Re: Notice to Proceed (NTP) Request #13 to Reconstruct Phase III of the Transmission Line (TL) 682 Component of the Cleveland National Forest Power Line Replacement Projects (Project)

Date Submitted:	02-15-18	Request #:	014
Date Approval Required:	03-29-18	Landowner:	Various
APN:	XXX-XXX-XX, XXX-XXX-XX, XXX-XXX-XX, XXX-XXX-XX, XXX-XXX-XX, XXX-XXX-XX, XXX-XXX-XX, XXX-XXX-XX, XXX-XXX-XX, XXX-XXX-XX, XXX-XXX-XX		
Refinement from (check all that apply):			
<input type="checkbox"/> Mitigation Measure	<input type="checkbox"/> APM	<input checked="" type="checkbox"/> Project Description	<input type="checkbox"/> Drawing <input checked="" type="checkbox"/> Other
Identify source (mitigation measure, project description, etc.):			
<p>In April 2015, San Diego Gas & Electric Company’s (SDG&E’s) responses to Data Request #10 were submitted to the California Public Utilities Commission (CPUC). The responses included Attachment B.4 TL682 Route Map¹ for the Cleveland National Forest Power Line Replacement Projects (Project), which depicted approved facilities, temporary guard structure sites, stringing sites, staging and fly yards, and access roads. In addition, the Bureau of Indian Affairs’ (BIA’s

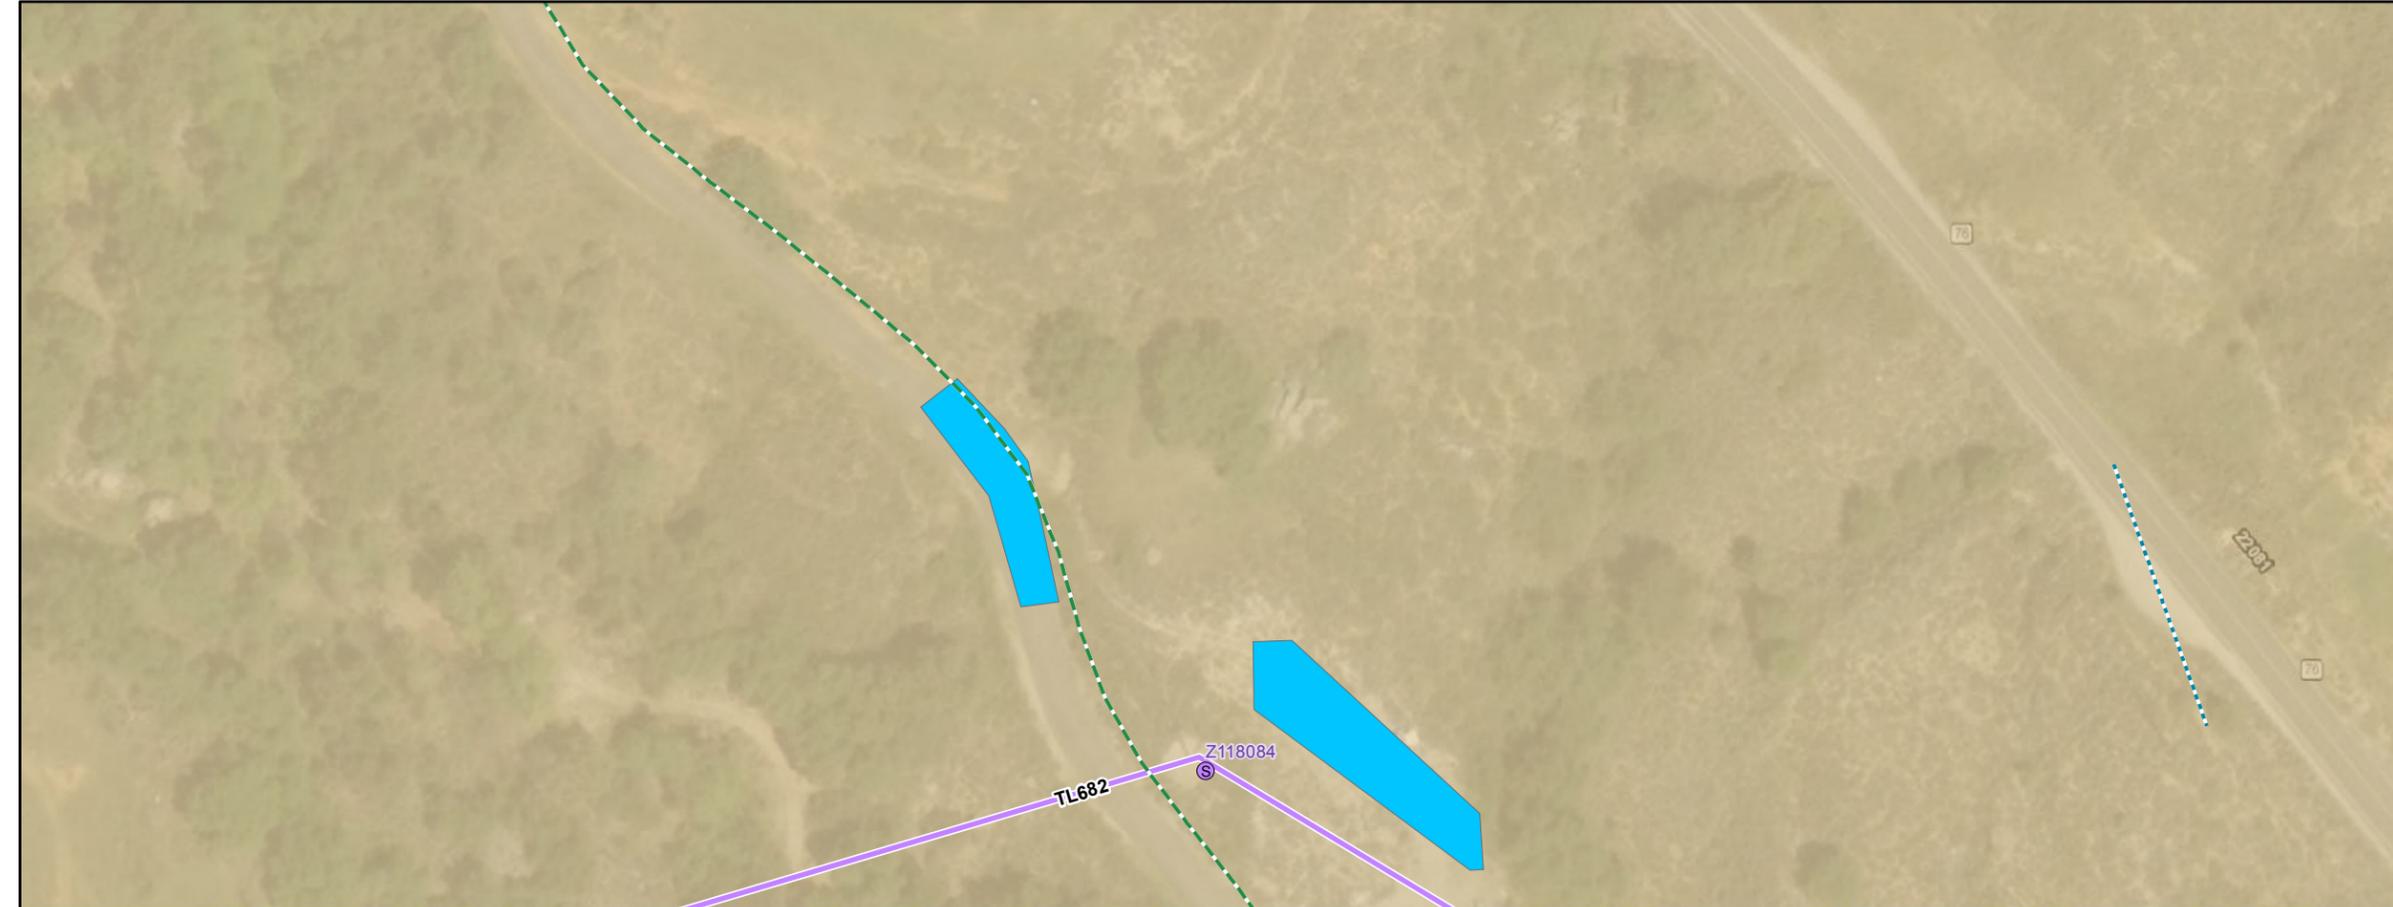
Notes:
2. The removal of Pole Z118085 (and the associated stub pole) was inadvertently omitted from the baseline data, but was always part of the approved Project. Therefore, it is not a change and not part of the MPR.
